OUR
TOWN
HALL
PROJECT

PROJECT STATUS	RIBA Stage 5
CLIENT	Manchester City Council
PROJECT	Our Town Hall
DRAWING TITLE	Roof ECRp01 proposed new timber roof Structure 3d views
SIZE & SCALE	A1:As indicated
DRAWING STATUS	S4 Construction
JOB NUMBER	236959
DRAWING NO.	OTH-PUR-TH-RF-DWG-A-4424 04
REV

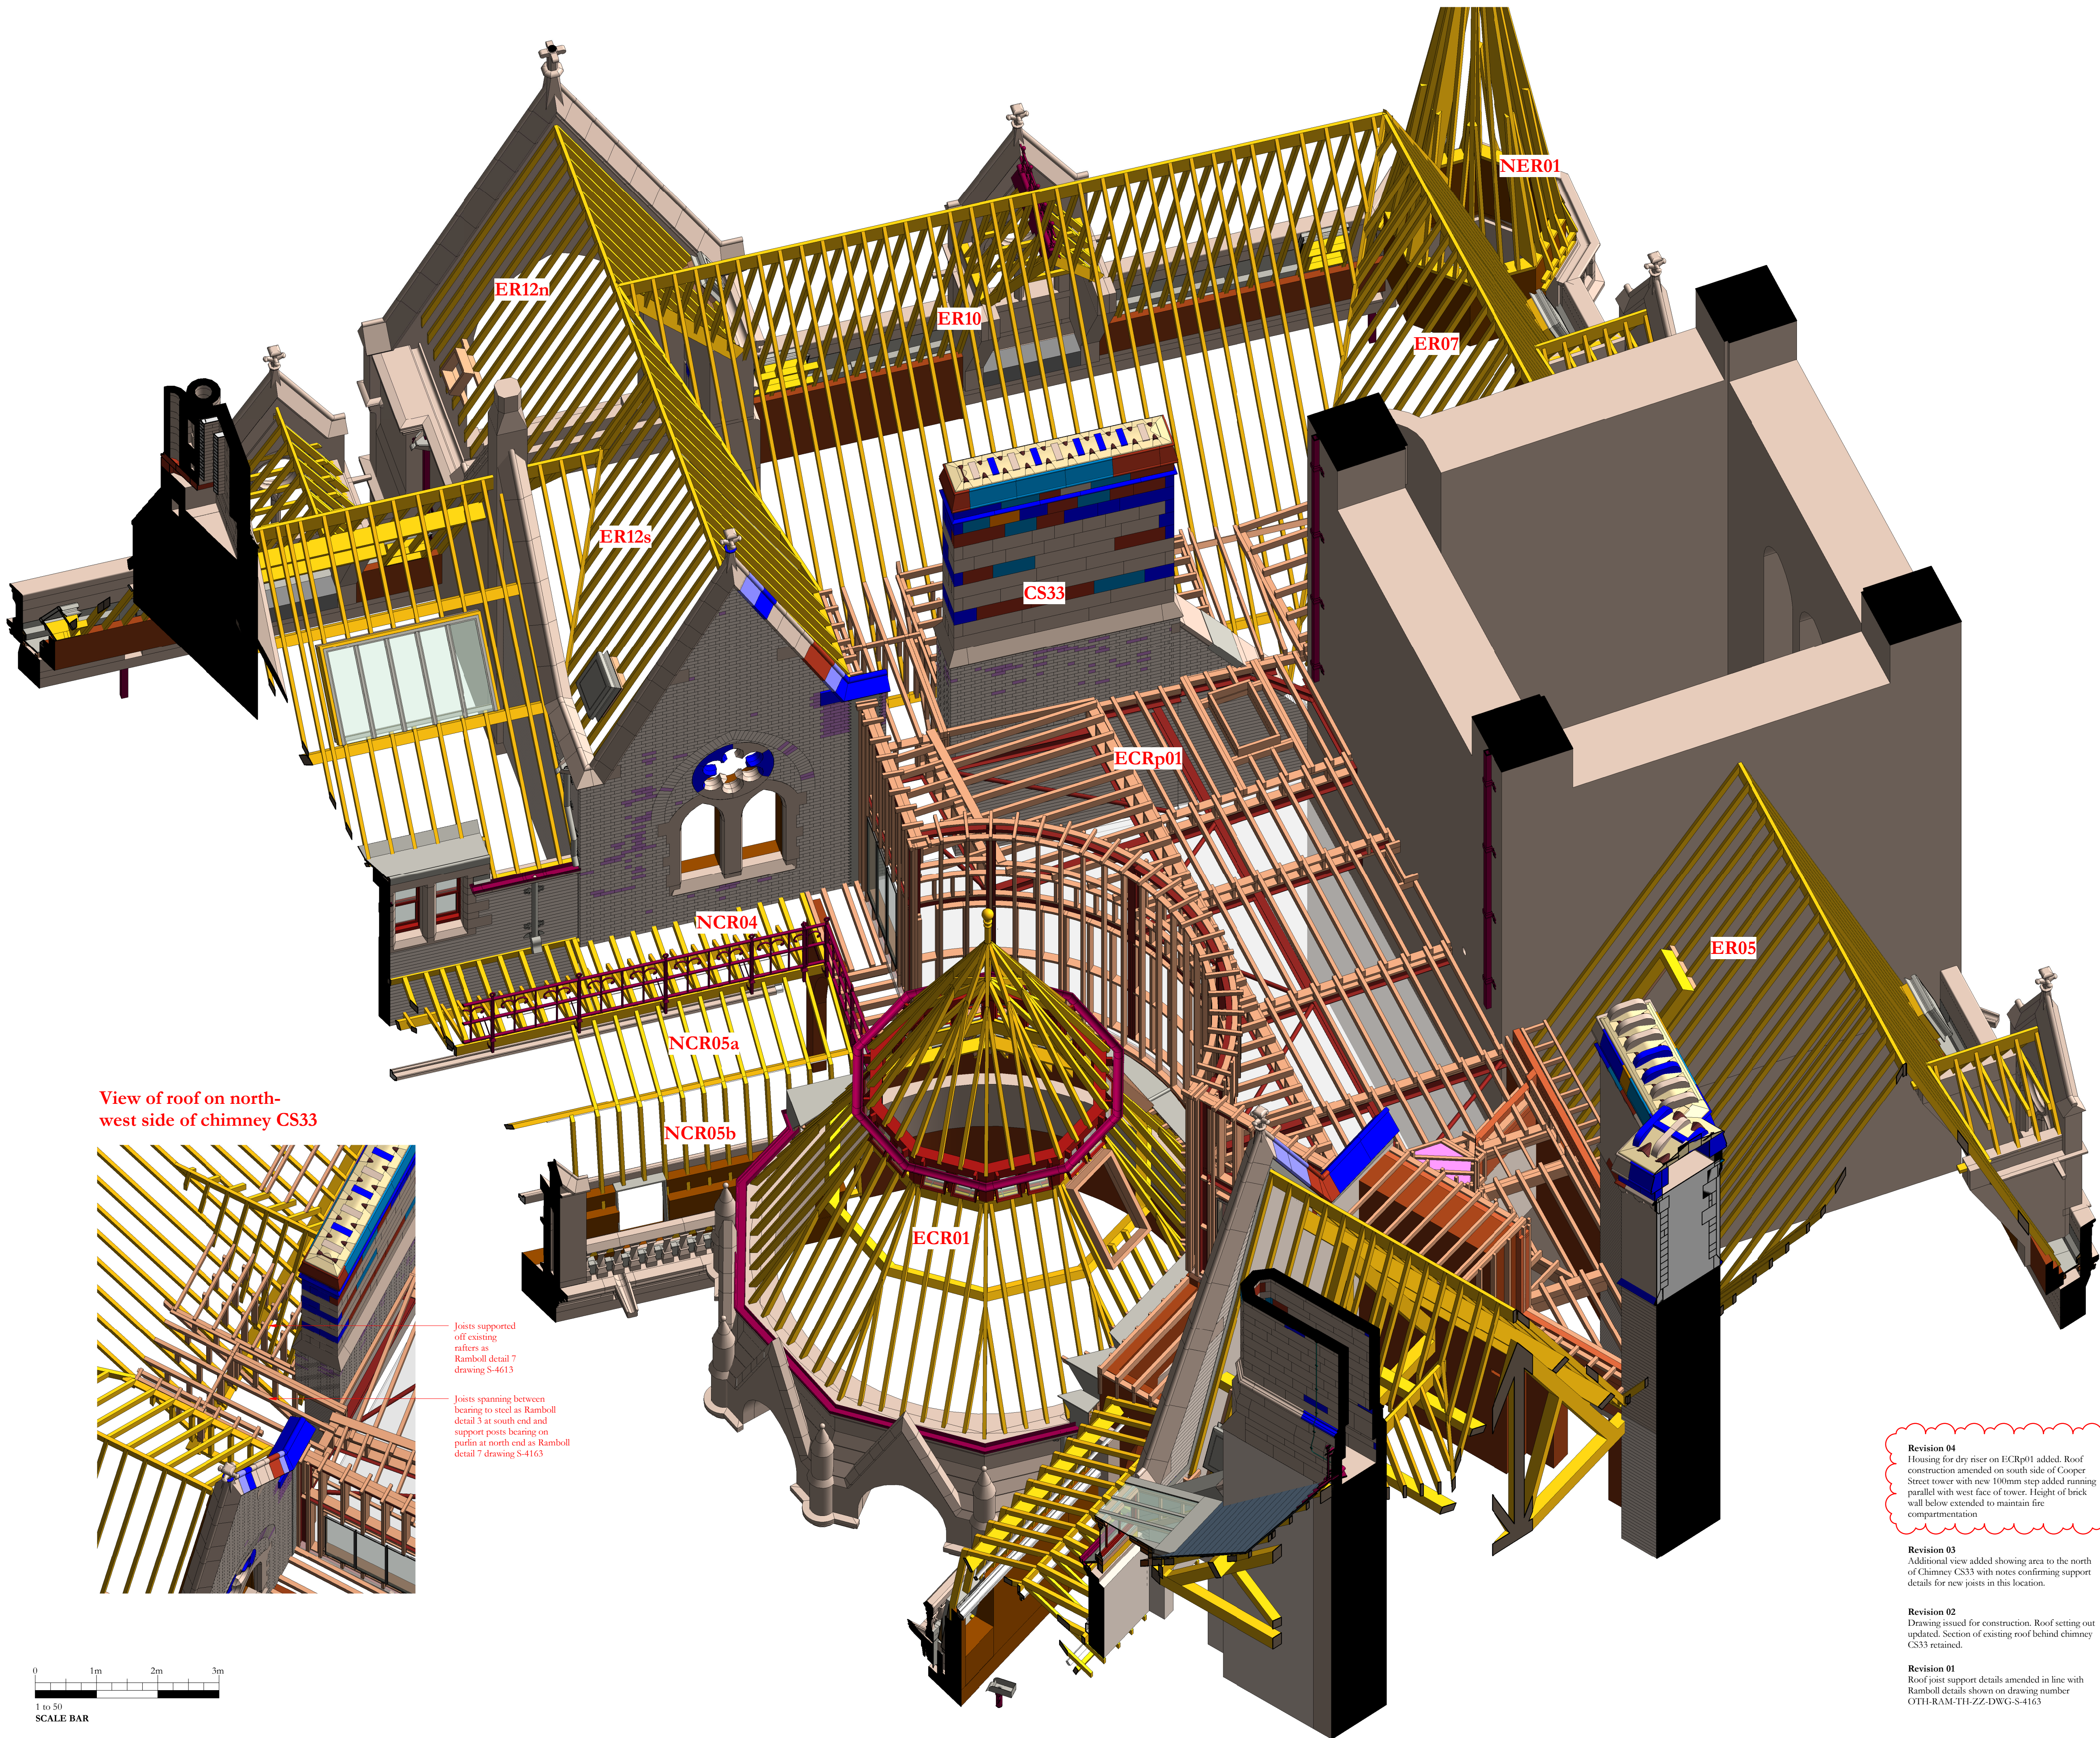
Revision 04
Housing for dry riser on ECRp01 added. Roof construction amended on south side of Cooper Street tower with new 100mm step added running parallel with west face of tower. Height of brick wall below extended to maintain fire compartmentation

Revision 02
Drawing issued for construction. Roof setting out updated. Section of existing roof behind chimney CS33 retained.

Revision 01
Roof joist support details amended in line with Ramboll details shown on drawing number OTH-RAM-TH-ZZ-DWG-S-4163

View of roof on north-west side of chimney CS33

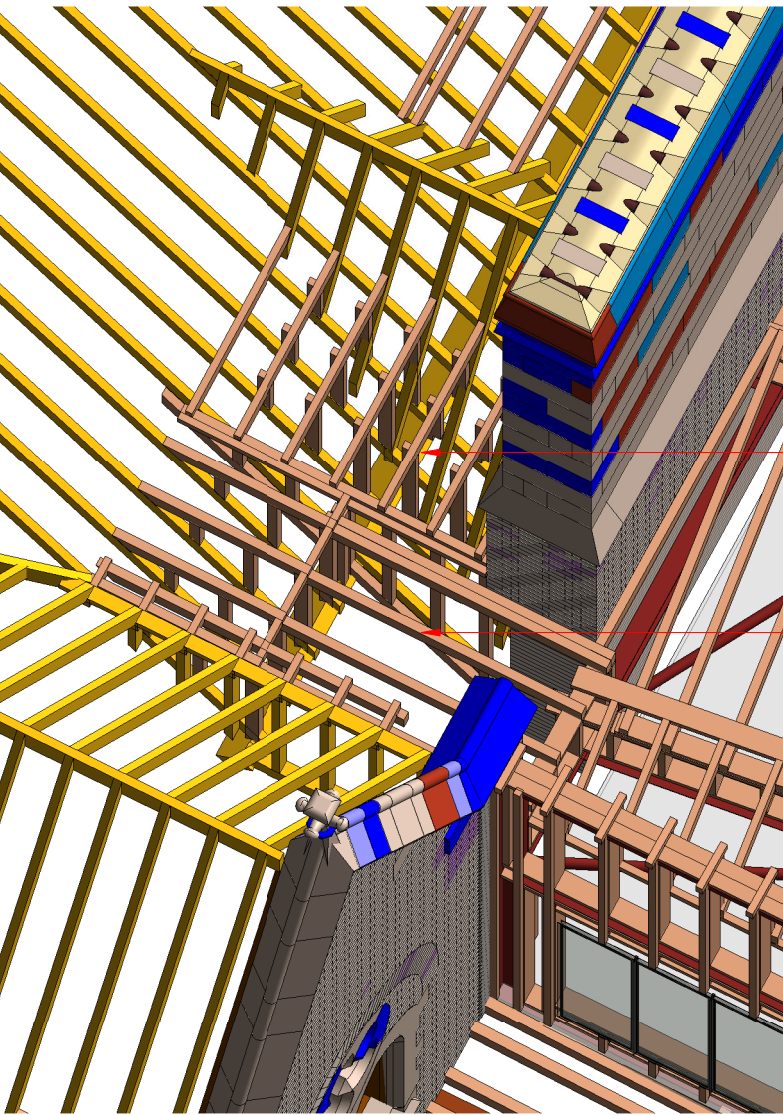
Joists supported off existing rafters as Ramboll detail 7 drawing S-4613

Joists spanning between bearing to steel as Ramboll detail 3 at south end and support posts bearing on purlin at north end as Ramboll detail 7 drawing S-4163

Revision 03
Additional view added showing area to the north of Chimney CS33 with notes confirming support details for new joists in this location.
